Wisconsin Department of Transportation

Proposal #28: 7900-00-70, WISC 2023399
C River Falls, Powell Ave
Kinnickinnic River Bridge P-55-0148
Loc Str
St. Croix County

This is Addendum No. 02, which provides for the following:

ADDENDUM NO. 2

Addendum No. 02
 ID 7900-00-70
 Revised Sheet 16
 April 25, 2023

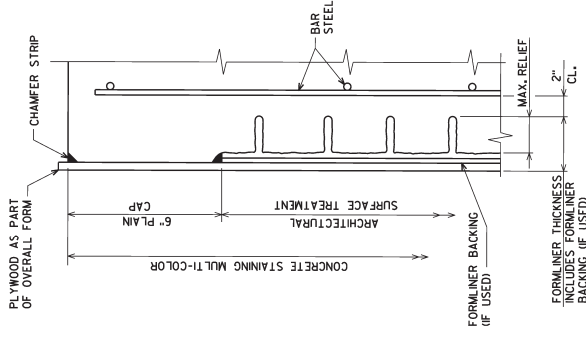
Addendum #1: Removed Maintaining
 Bird Deterrent System Item

NO.	DATE	REVISION	BY
04/23		FORMLINER DETAILS	APRES
STATE OF WISCONSIN DEPARTMENT OF TRANSPORTATION			
STRUCTURE P-55-148			
TYPICAL SECTION, DESIGN DATA, AND NOTES			
SHEET 2 OF 17			62

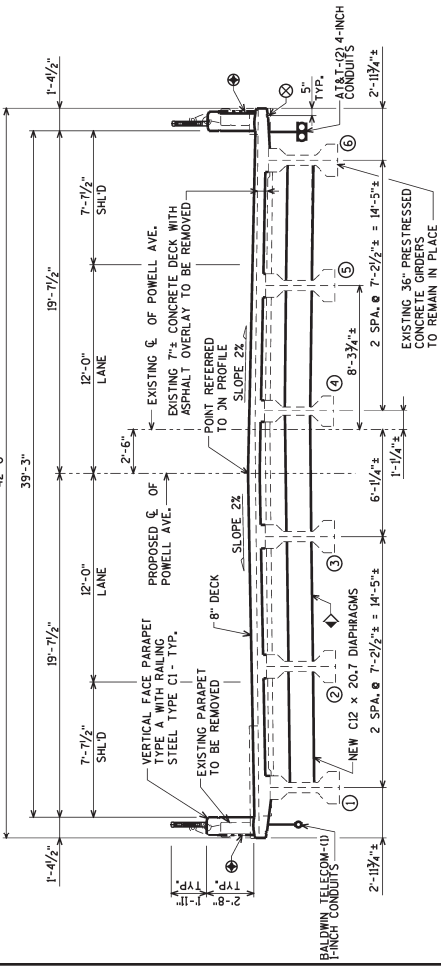
Revised Plan Sheets	
Plan Sheet	Plan Sheet Title (brief description of changes to sheet)
16	Miscellaneous Quantities (removed Maintaining Bird Deterrent System item)
62	Typical Section, Design Data, and Notes (revised formliner dimension)

RECTANGULAR CUT STONE
 FORMLINER THICKNESS = 4" TO 9/2"
 COURSE HEIGHT = 2 1/2" TO 3"
 MAX. RELIEF = 3/4" TO 1 1/2"
